PLANNING BOARD AGENDA

**OCTOBER 06, 2025
REGULAR MEETING**

**TONELLI, JAMES
1808 FERNWOOD RD.
BLK - 14 LOT - 40**

**STUTO, JOSEPH
399 NORTH BOULEVARD
B - 18 LOT - 20**

PLOT/GRADING PLAN FOR #3 RIPLEY LANE
LOT 17, BLOCK 16, BORO OF LAKE COMO
MONMOUTH COUNTY, NEW JERSEY

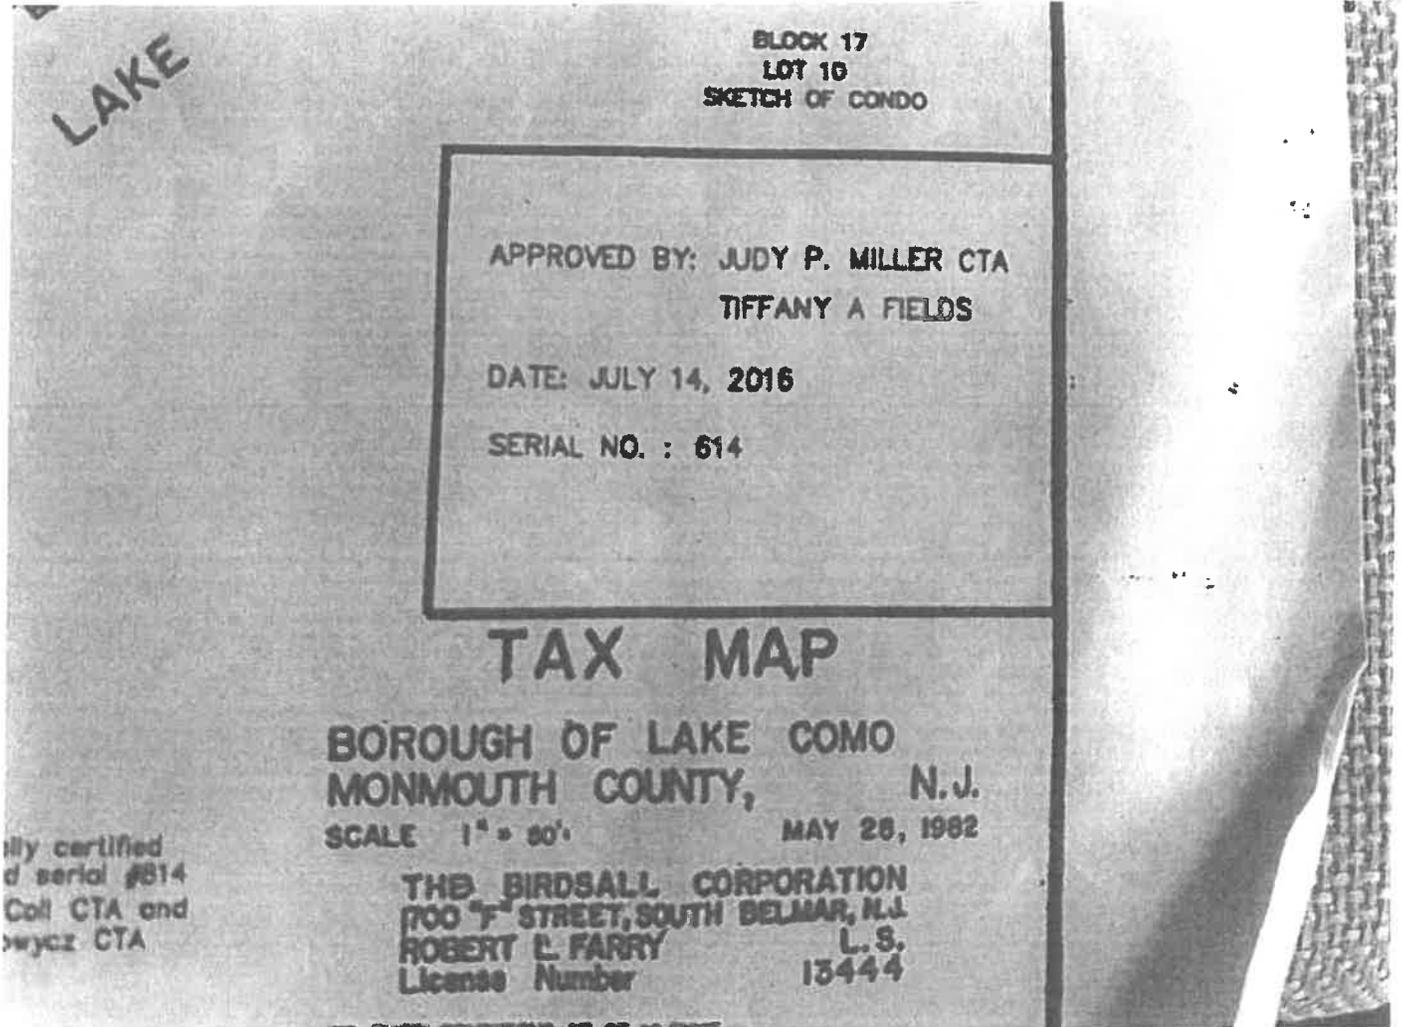
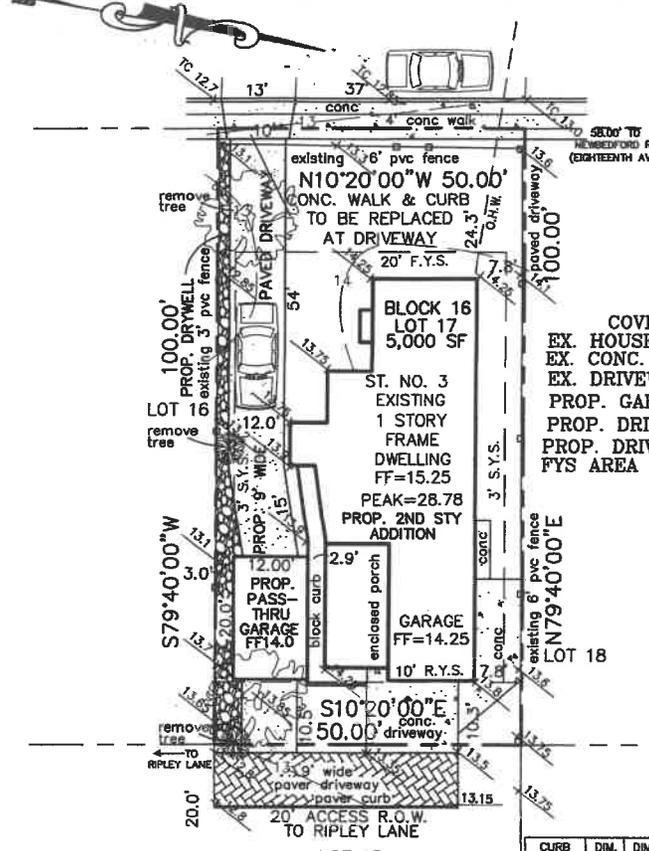
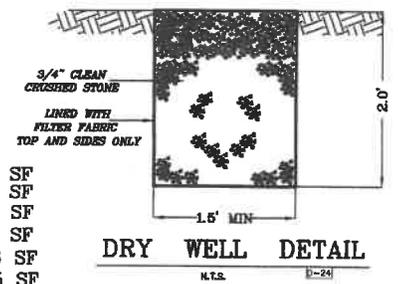
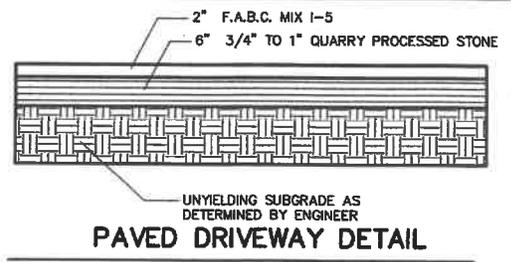
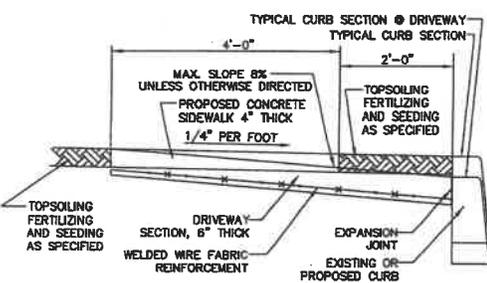
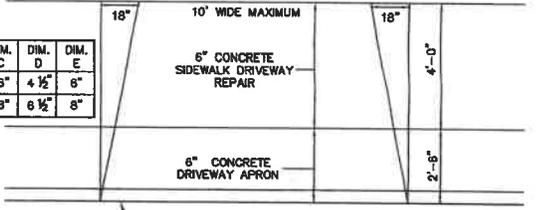
1. Ordinance 2024-01 specifies the requirements for drywells and seepage pits for new structures and additions. A drywell is proposed on the Plot/Grading Plan; however, it appears to be established along the surface of the entire southern boundary shared with Lot 16. Ordinance

2024-01 establishes that drywells must be located 5 feet from any property line and must have a minimum of two feet of cover. Additionally, roof leaders from the proposed pass-through garage and additions, including the enclosed porch. Variances are required for the three (3) identified non-conformities: (1) drywell within 5 ft setback, (2) drywell does not achieve 2ft minimum cover, and (3) roof leaders not included on Plot/Grading Plan.

NORTH BLVD.
PLOT PLAN 00
1"=10'-0"

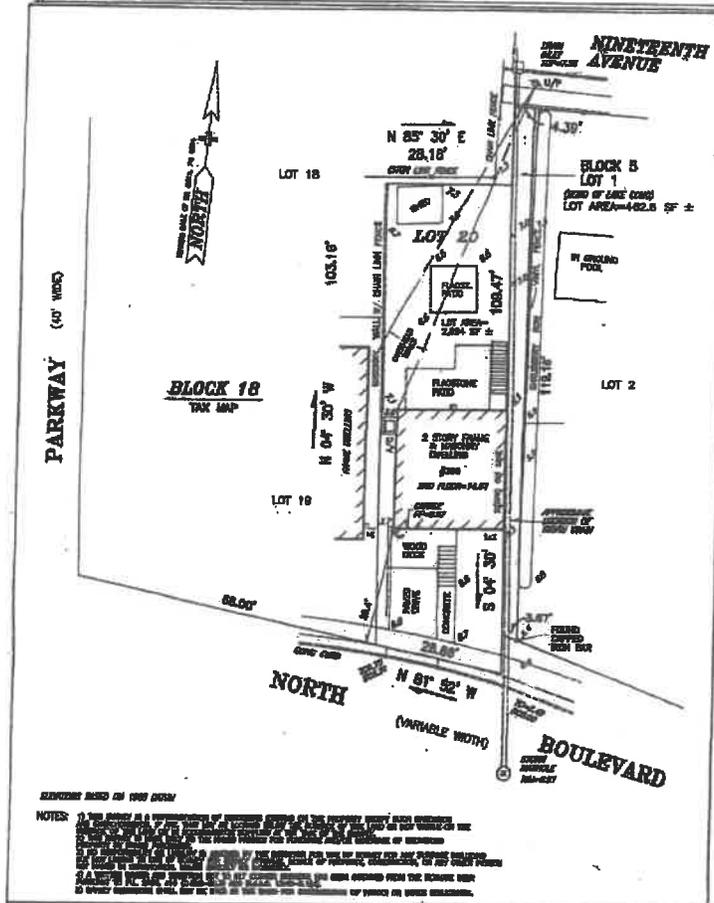
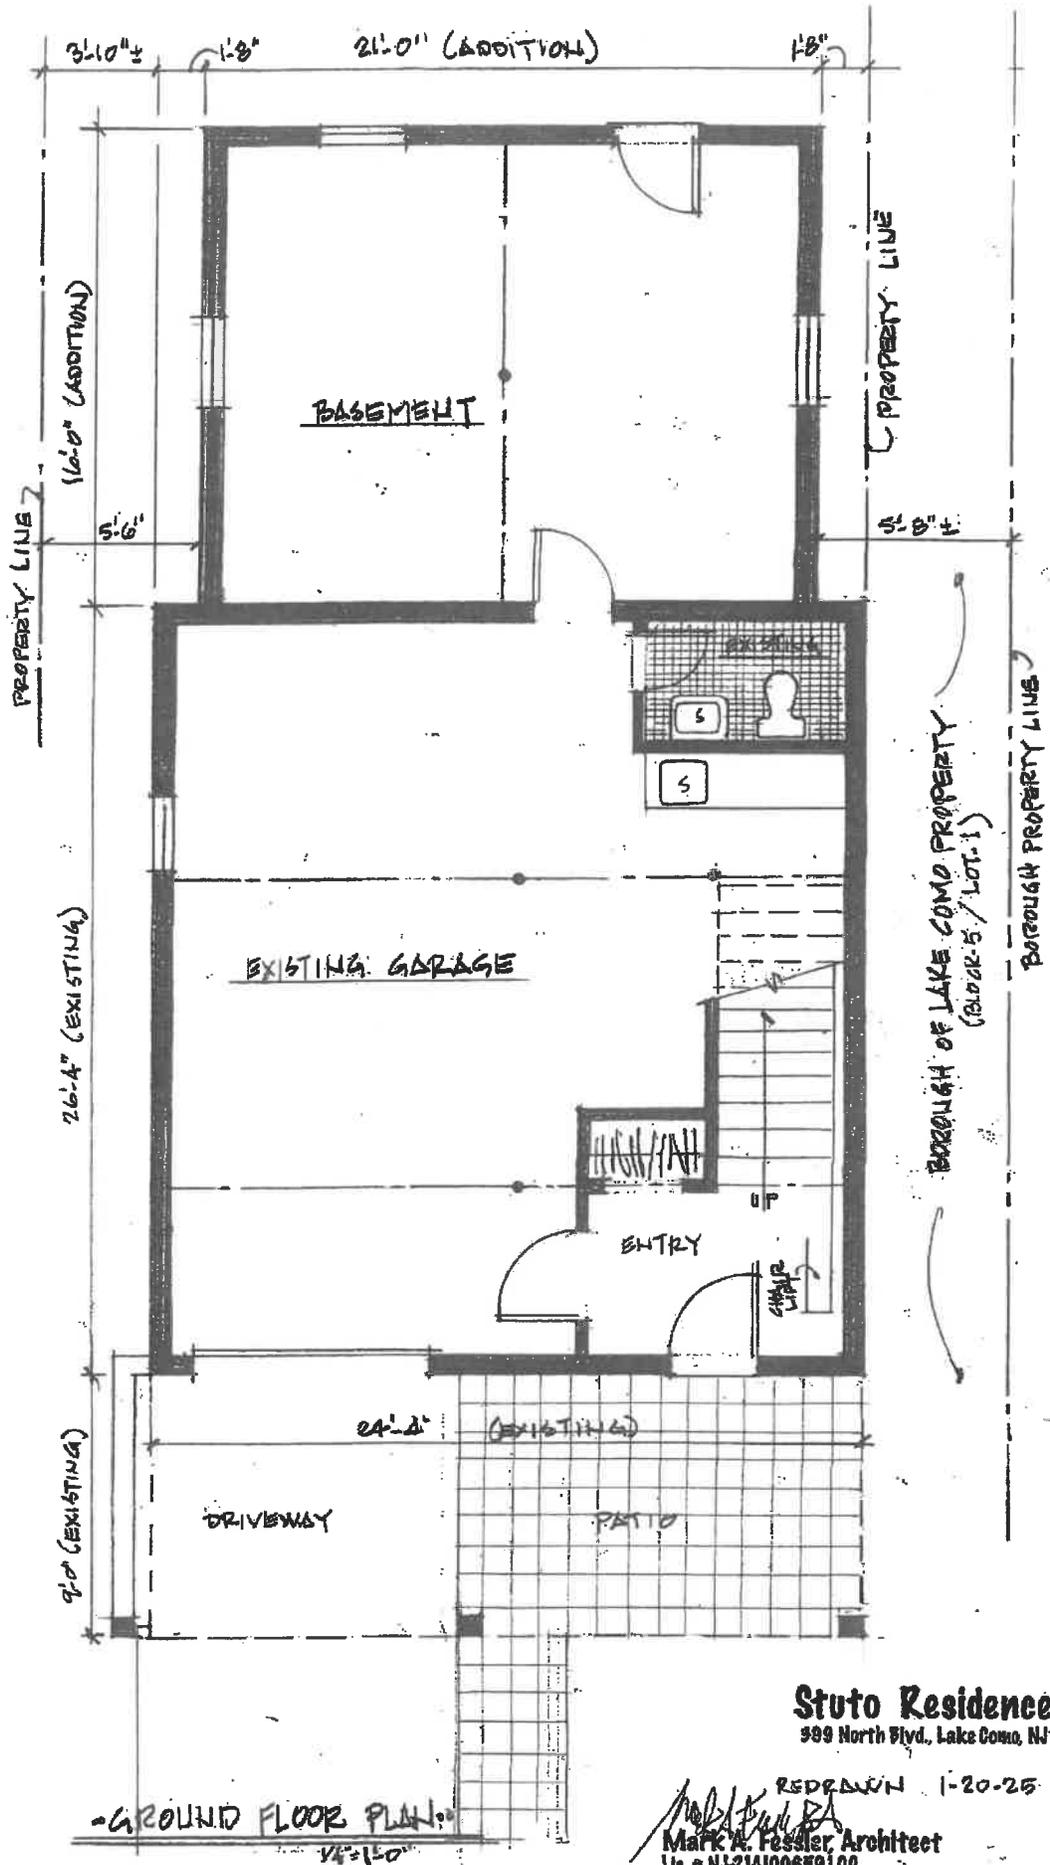
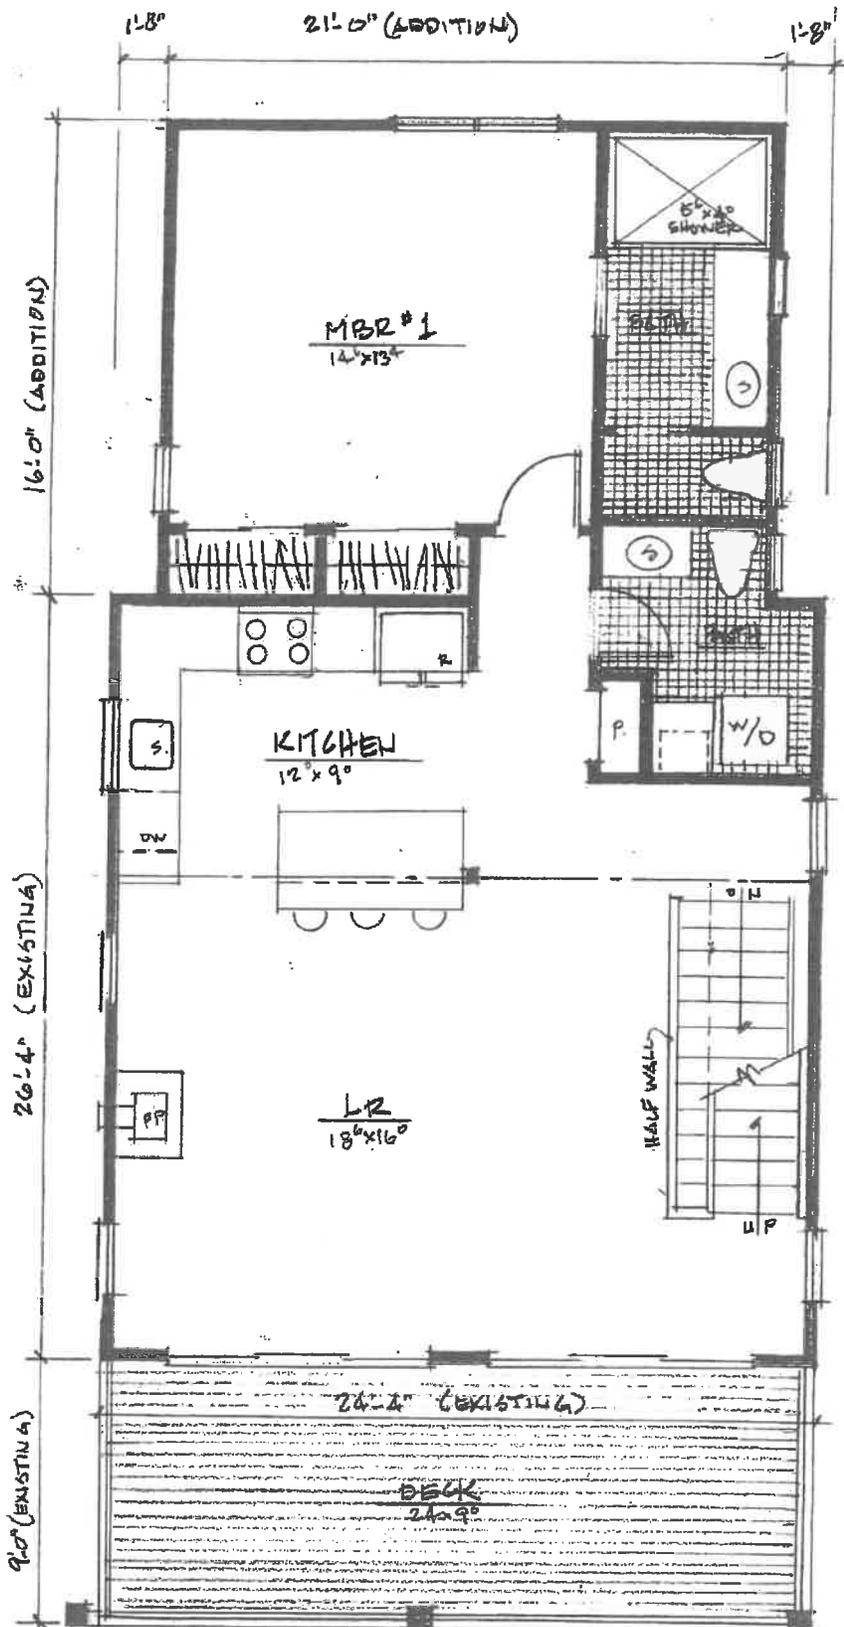
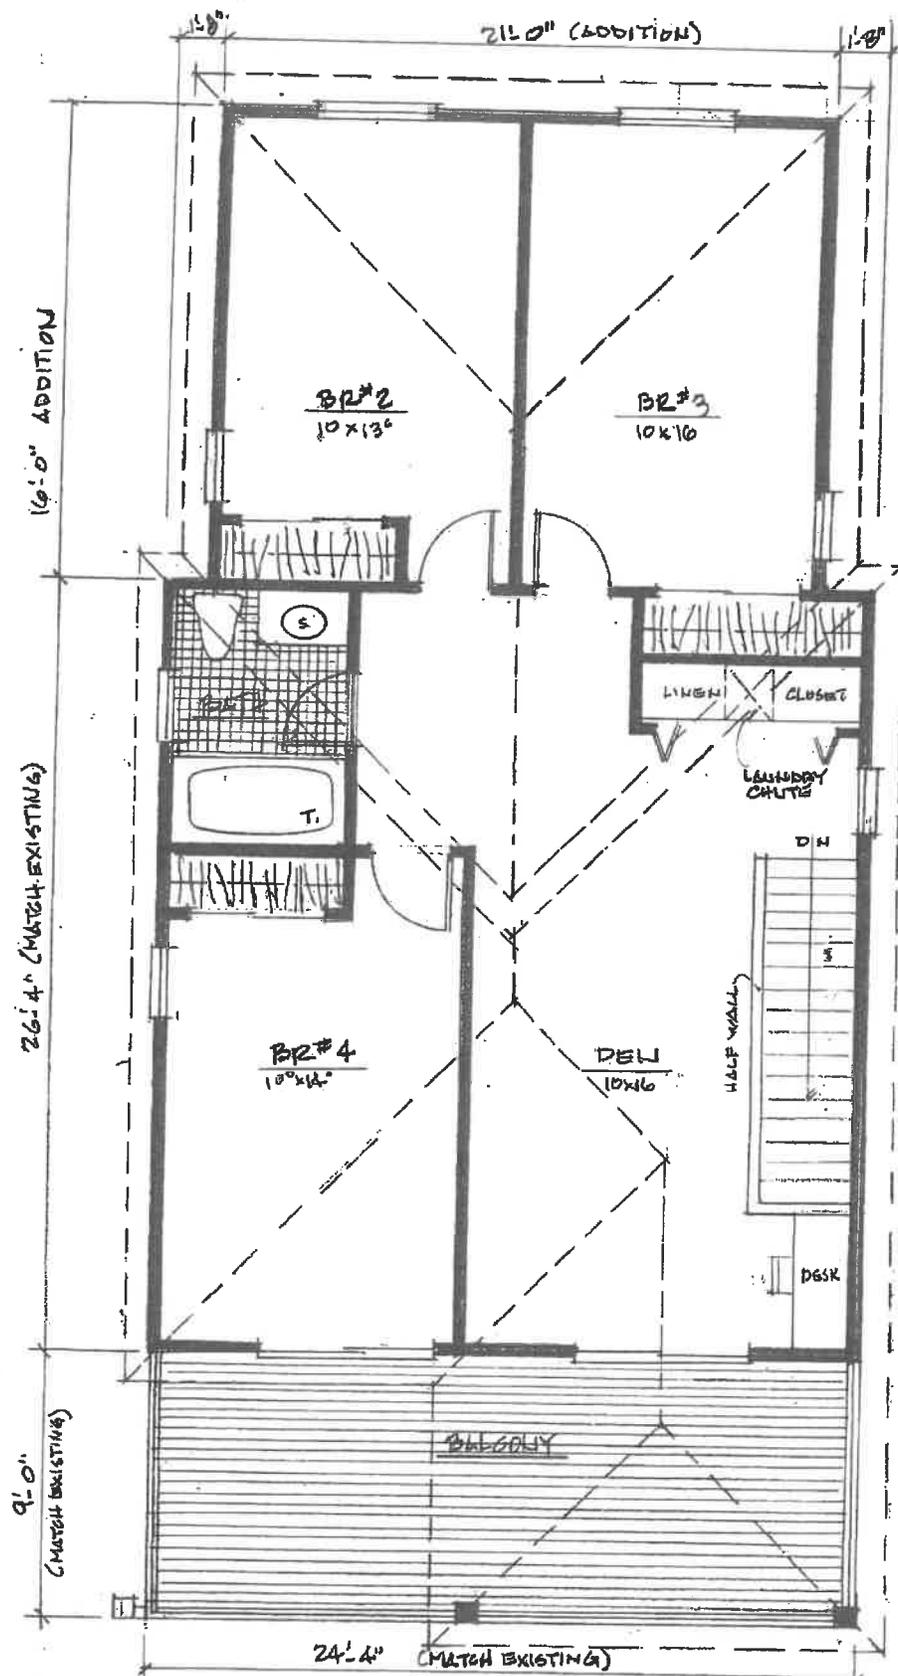
2. We have noted scaling discrepancies across the Survey, Plot Plan and Architectural Plans that should be revised prior to final submission to ensure consistency between reported dimensions and scaled dimensions.
3. There is no Grading Plan provided and topographic contours/elevations are not represented on the Plot Plan. There is no information provided regarding intended stormwater management at the site. The Board should elicit testimony regarding stormwater management and condition any approval on submission of an acceptable Grading Plan.

My submitted drawings revision dated 1/4/2025 were numerically dimensionally correct, however, some of the drawings were slightly out of scale graphically. The numbers shown were all correct but some of the drawings were slightly out of scale.

As per Alan Hilla's request, I have redrawn everything so that the drawings are now both graphically and dimensionally correct. These redrawn drawings have been dated 1/20/2025.

A-7

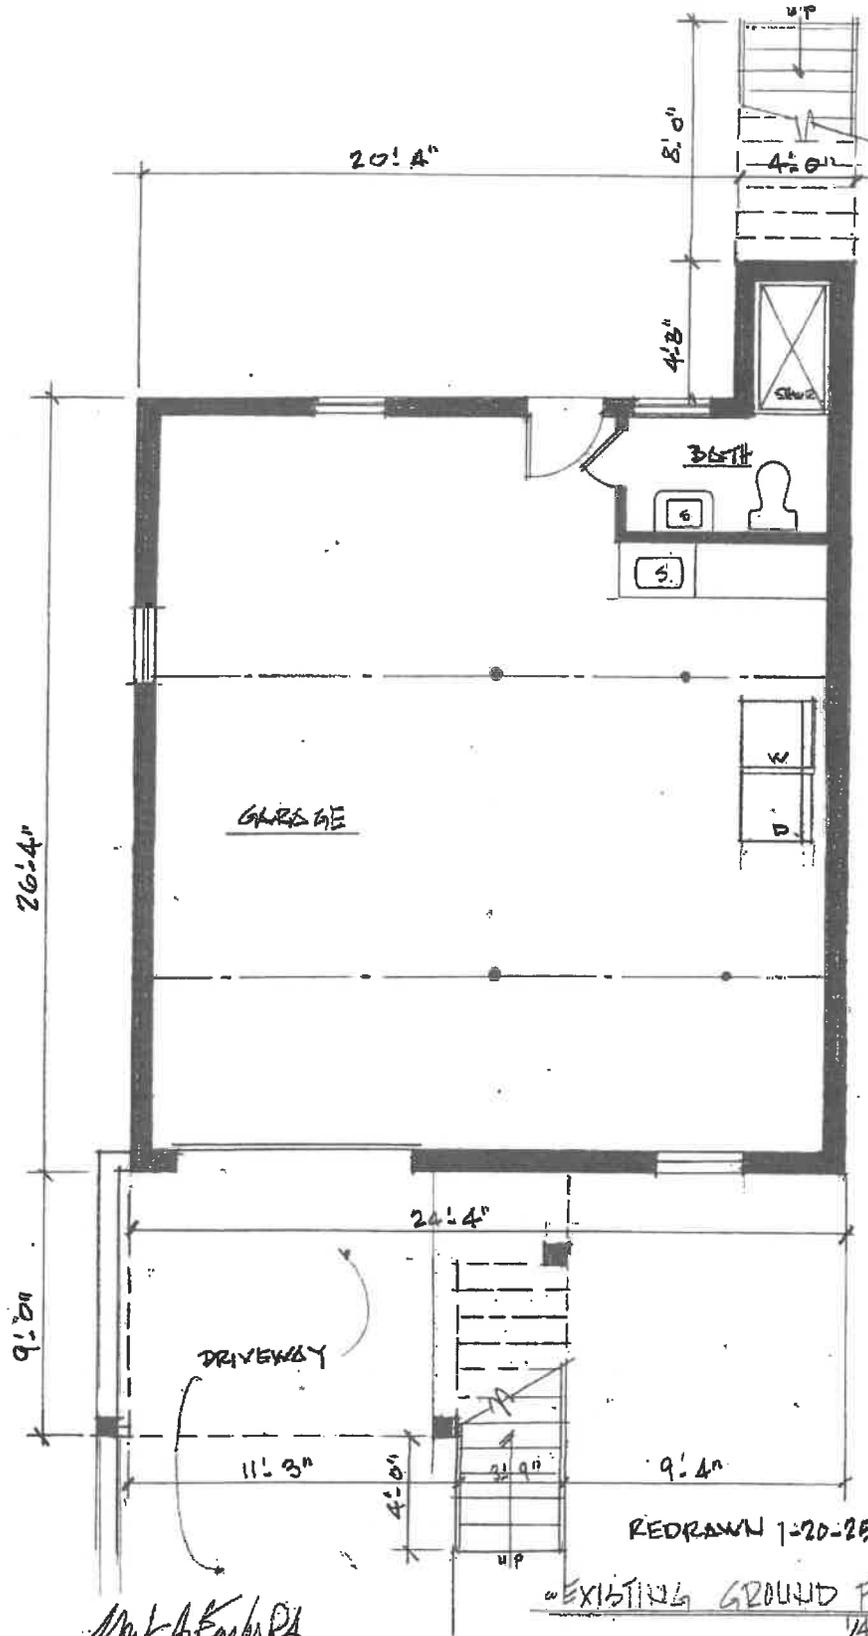
5. Sheet A-7 appears to be an unscaled close-up of the property survey with hatching in the previously mentioned adjacent land strip. This sheet should be modified as it promotes confusion with respect to the adjacent Borough property and its relationship to the Applicant's property.
